Product Change Notice (PCN)

PCN Number: PCN-0384612R-01

Product(s) Affected: CMS-18138A-SP

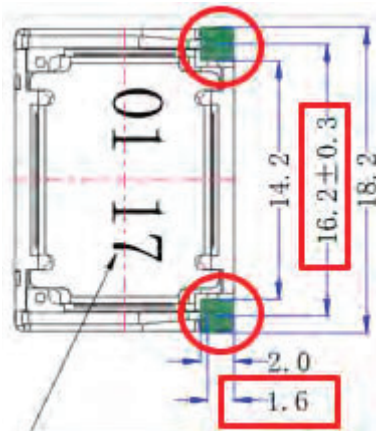
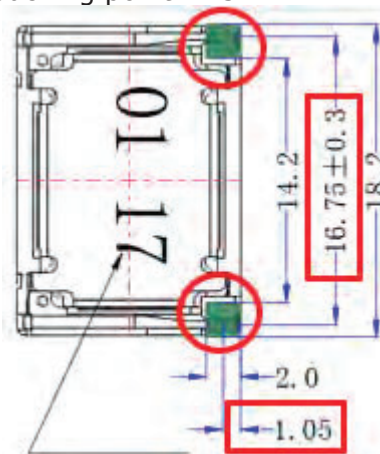
Description of Change: Spring contacts replaced. PCB layout unchanged.

Previous:

Pin Pitch- 16.2 ± 0.3 mm
 Touching point- 1.6 ± 0.2 mm

New:

Pin Pitch- 16.75 ± 0.3 mm
 Touching point- 1.5 ± 0.2 mm
